February 9, 2005

U.S. Department of Transportation  
National Highway Traffic Safety Administration  
Office of Defects Investigation  
NSA-10.01, 400 7th Street, SW  
Washington, DC 20590

Enc: Two Photographs of Selector Lever Designs

1986 Chrysler LeBaron Selector Lever

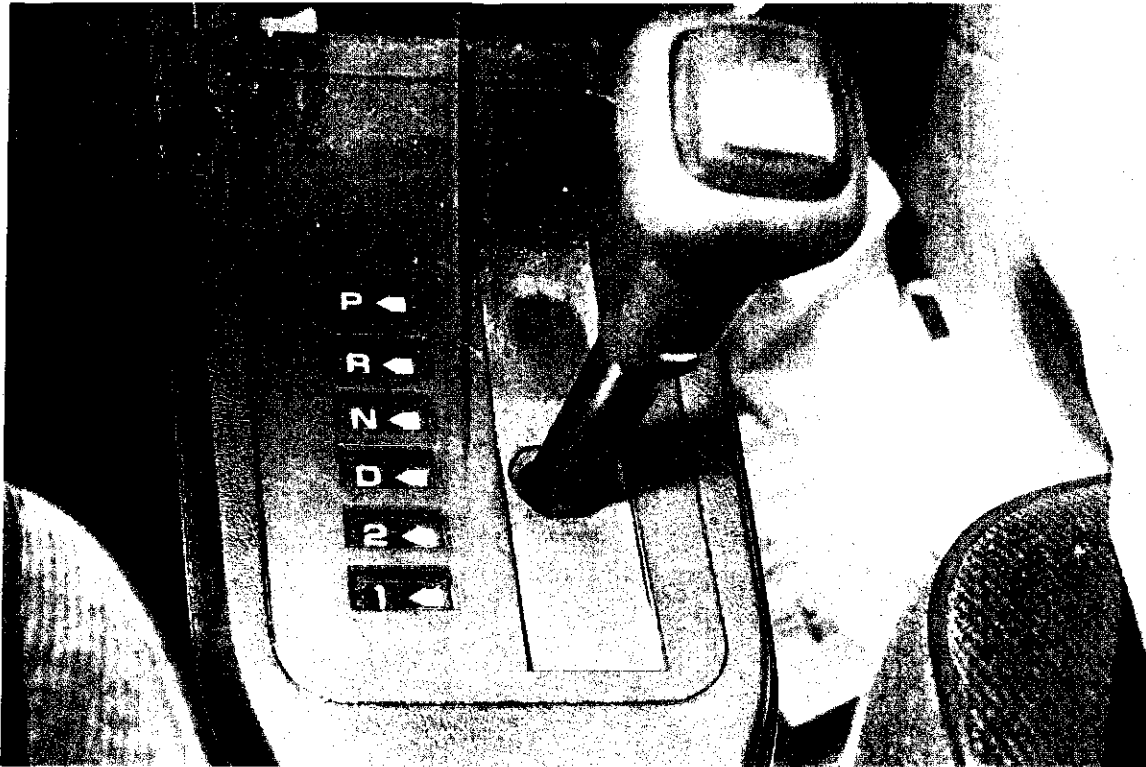
The [REDACTED] incident is only one example of many incidents of this type I have investigated. Accidents of this description occur commonly and can be prevented by a simple modification of the selector lever. The selector lever for the [REDACTED] vehicle is shown in the enclosed photograph. This is a typical console-mounted selector lever. Note that a palm button is used to control movement into and out of PARK. The position indicator (the PRNDL indicator) is vague, hard to read, and, for this vehicle, not illuminated. The indicator is particularly hard to see at night, when the [REDACTED] incident occurred. Observe, for comparison, the selector lever shown for the 2003 Subaru. This design, which is notched and requires the driver to use lateral motion to place the lever into or out of PARK, makes the driver well aware of the selector lever position. This simple, nearly cost free, design will virtually eliminate the confusion where the driver believes the lever is in PARK while, in fact, it is in ILLUSORY PARK.

It is established that drivers rarely use the PRNDL indicator to determine whether they are in PARK. They use the end-of-travel indication. History has shown that this is not a suitable indicator. If lateral motion was required the driver would know with certainty that the system is in PARK.

2003 Subaru Selector Lever Design

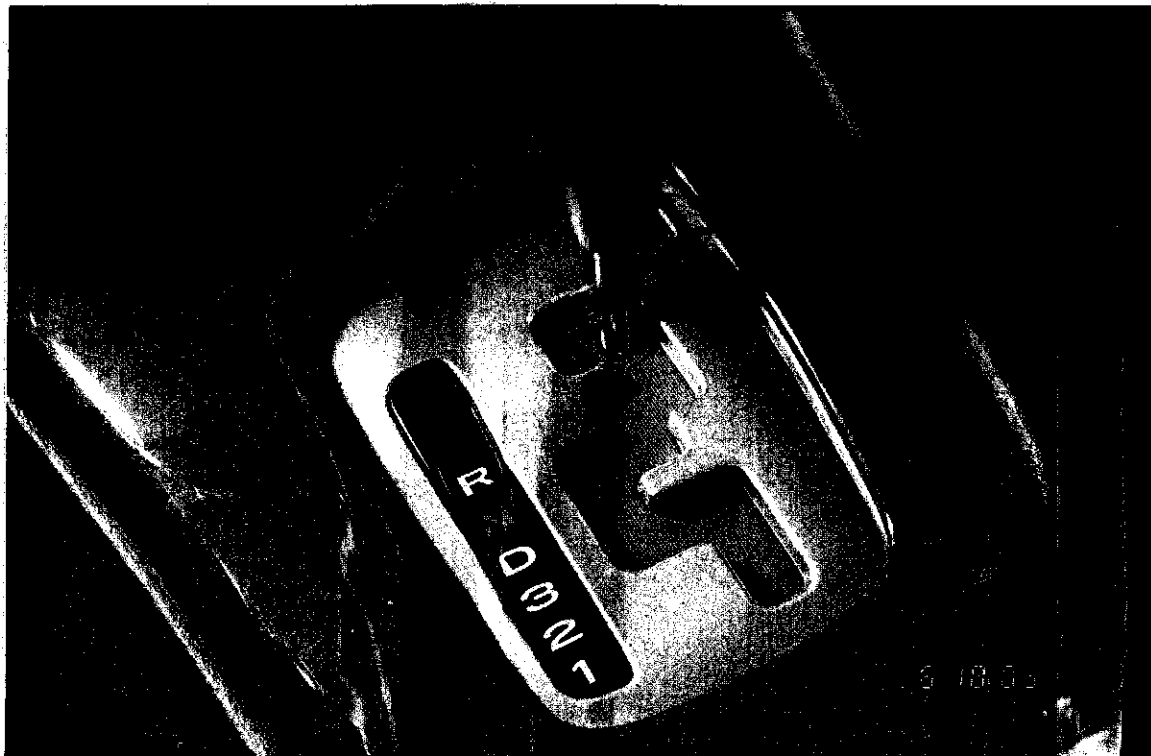
NHTSA has studied the issue of ILLUSORY PARK for many years. There was a "C2" report issued in the late 1960's. Certainly car manufacturers have improved the selector lever system over time. For example, they now rarely use a flat zone on the contour of the inner manual lever between PARK and REVERSE, while at one time this was common. I suggest that now is the time to require manufacturers to incorporate this notched, lateral-motion design into their selector levers that would virtually eliminate ILLUSORY PARK incidents for those cars that use a console-mounted selector lever. Some, but not all, new cars use lateral motion to control motion of the selector lever. My request is that you make it a requirement that all console mounted selector levers be properly designed with this feature.
